Florida Department of Transportation

SUBJECT: Temporary Design Bulletin C06-10
DCE Memorandum No. 28-06
Mandatory Utilization of Embedded Data Collectors (EDC) in Prestressed Concrete Test Piles (2 pages)

EDC INSTRUMENTATION FOR
SQUARE PRESTRESSED CONCRETE PILES

30" SQUARE PRESTRESSED CONCRETE PILE

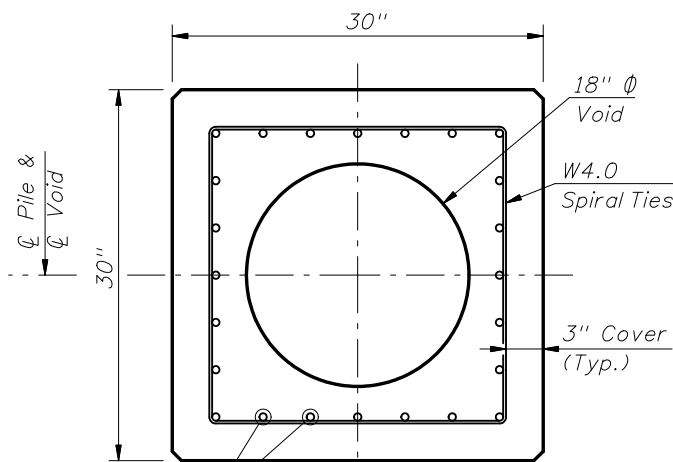
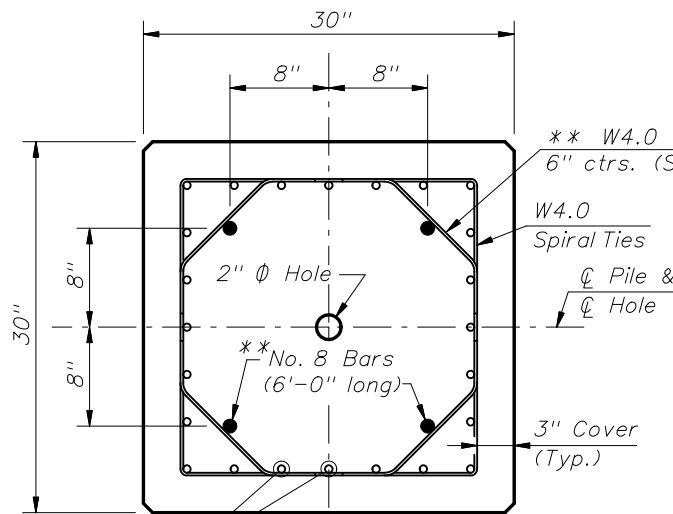
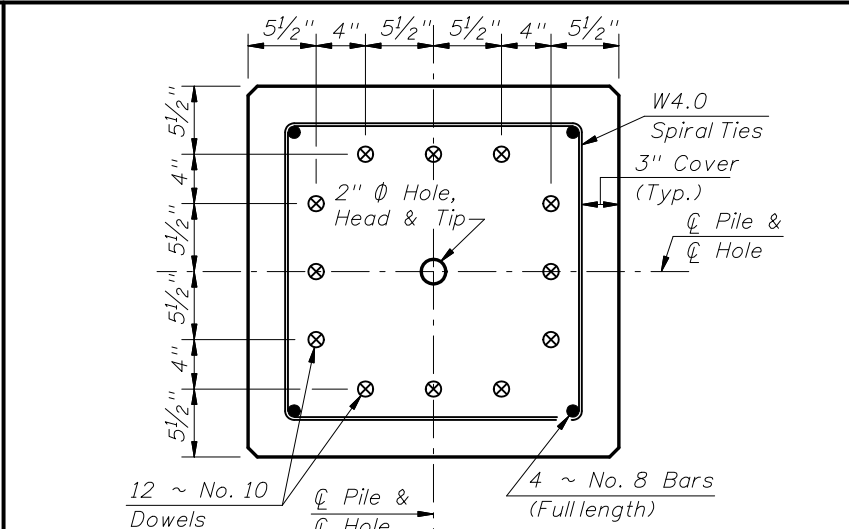
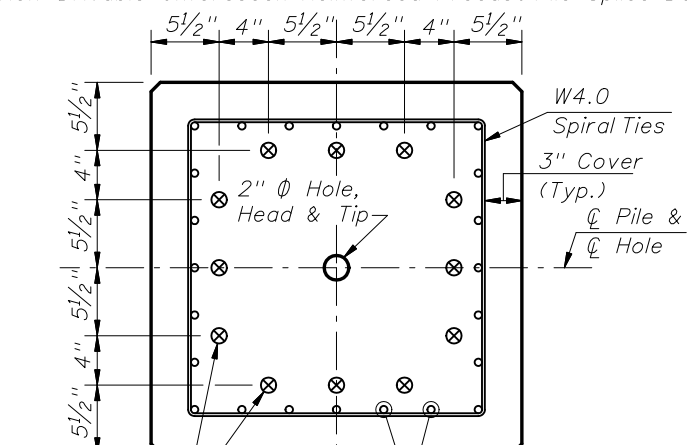
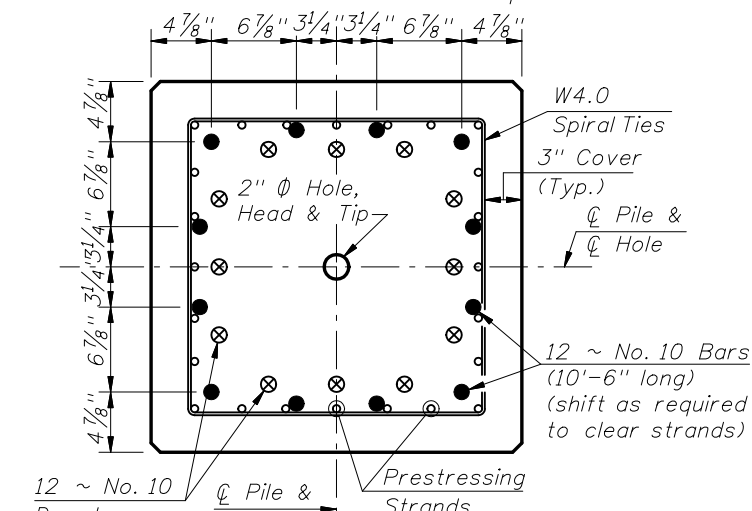
EDC can not be used with steel pipe piles or H-piles. In voided prestressed concrete piles, the length of the solid sections at the tip and toe of the piles shall be at least 4 pile diameters long. Design Standards Index 20630 for 30" Prestressed Concrete Piles has been revised to extend the solid section at the head and toe and will be released as an interim standard along with the interim standard for the EDC. The EDC will be cast into these solid sections, along the axis of the pile, ≥ 2 pile diameters from the end and ≥ 2 pile diameters from any cross-section change such as a pile void or vent.

DATE	BY	DESCRIPTION	DATE	BY	DESCRIPTION
01/01/06	CEB	Added dimension "4'-0" Solid Section - Typical for Pile" & "11'-0" Solid Section - Typical for Splice Section" to ELEVATION.	11/07/06	LEJ	Deleted 2" Ø hole in tip solid section. Deleted 3/4" Ø hole in opposite sides of pile. Changed 4'-0" Solid Section to 11'-0" Solid Section & changed Note 1. Added "Head & Tip" to "2" Ø Hole" in PILE SPLICE DETAILS.

1. Venting shall be provided by the use of a 1" Ø PVC conduit through a substructure cap or column. Voids between segments of spliced piles shall be connected by 2" Ø hole(s).
2. Any of the given Alternate Strand Patterns may be utilized. The strands shall be located as follows: Place one strand at each corner and place the remaining strands equally spaced between the corner strands. The total strand pattern shall be concentric with the nominal concrete section of the pile.
3. CONTRACTOR OPTION: The 30" pile may be cast SOLID by omitting the 18" Ø void, the 2" Ø holes and the 3/4" Ø vent holes. In this event, the Contractor shall submit calculations for approval and a proposed strand configuration that provide net prestressing after losses equal to 1000 psi.
